**MODIFICATION REQUEST:
Newcastle Gas Storage Facility
Tomago, NSW
(MP 09_0150 Mod 1) – Concrete Washout
Facilities**

Director-General's
Environmental Assessment Report
Section 75W of the
Environmental Planning and Assessment Act 1979

January 2013

Figure 3: Proposed Modified Layout

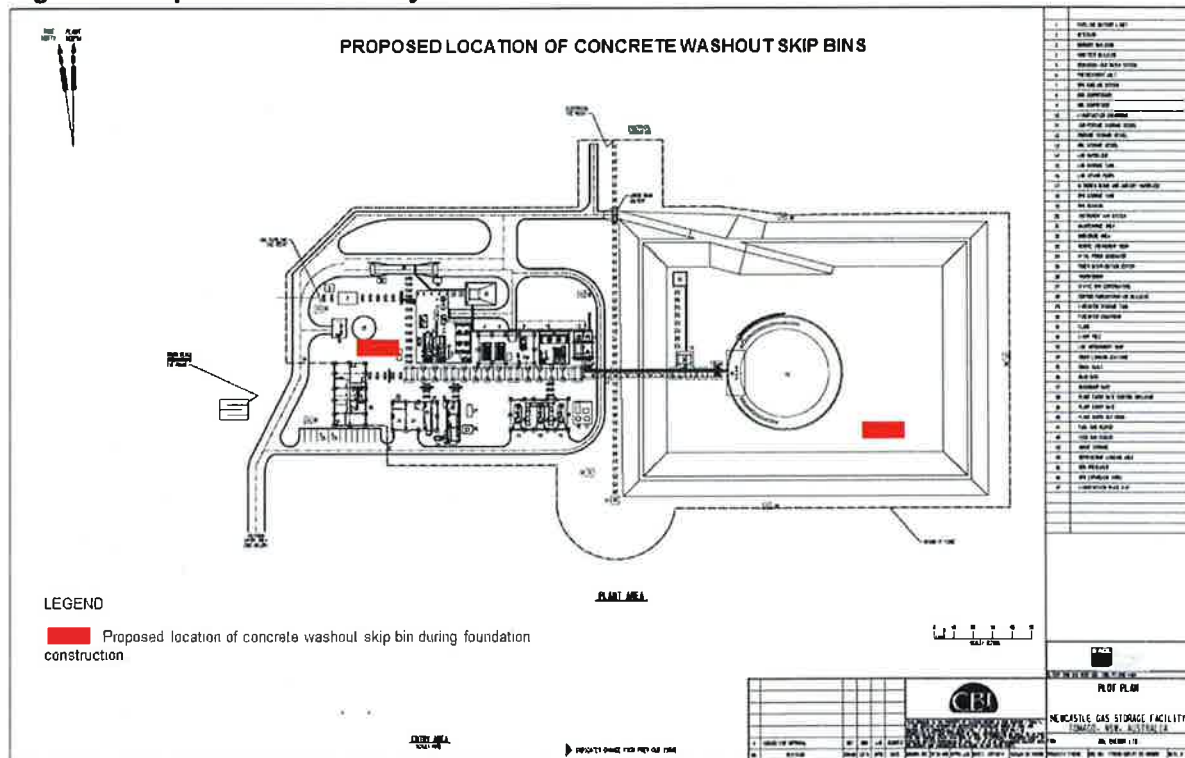
The modification request seeks to authorise the washing out of concrete mixers and pump trucks on site during construction of the gas storage facility, using three concrete washout skips (CWS) with capacity of 3 cubic metres each and a combined capacity to capture up to 9,000 litres of wastewater. The CWS would be placed in close proximity to the area of the largest pour, and a minimum of 20 metres from storm drains, open ditches or water bodies.

The indicative locations of the CWS are shown in **Figure 3**.

Figure 4: Proposed Modified Layout

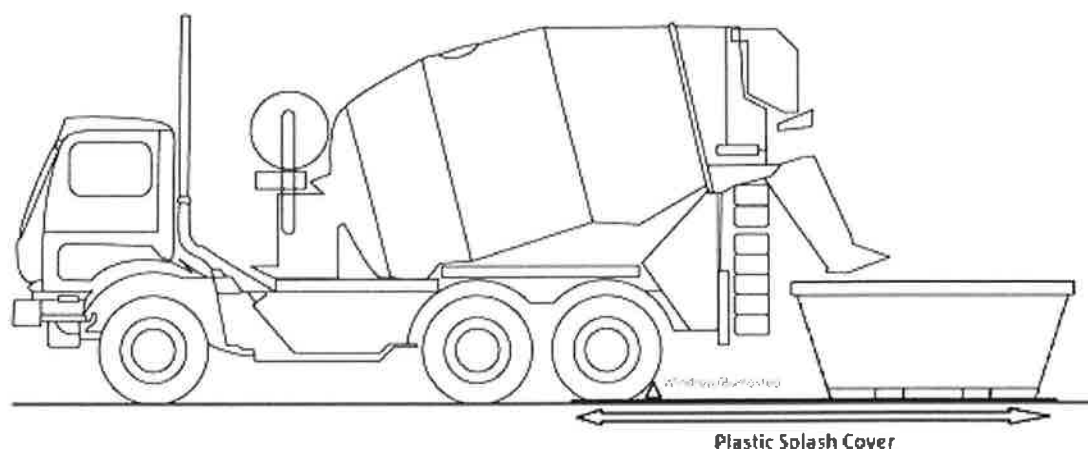
Aspect	Description
Concrete Washout Skips	<ul style="list-style-type: none"> The CWS would have a combined capacity of 9,000 litres. This capacity meets the minimum of 120% capacity to capture waste water generated during the most intense concrete pours. The use of three skips, side by side, would enable one to be pumped out, while the other two are being used. The skips would be clearly sign-posted, underlain with a plastic splash sheet and have a windrow or bump stop to guide trucks into the position. The skips would be water tight and have a cover to prevent rainwater intrusion. Each skip would be lined with plastic to prevent concrete waste hardening to the side and have a marker to indicate maximum capacity. A description of the concrete washout procedure is in Figure 4. Pump-out trucks would be required to enter the site to remove the wastewater from the skips. During the largest concrete pour (estimated at 450 cubic metres) there would be two such pump-out truck movements per day. However, there would be only three such pours over a six to ten week period. This would reduce to once per day for larger pours (approximately 200 cubic metres). All waste collected in the CWS will be transported to a local batching plant, disposed of at an approved landfill or by a waste concrete recycler. No additional clearing is required to install the CWS.
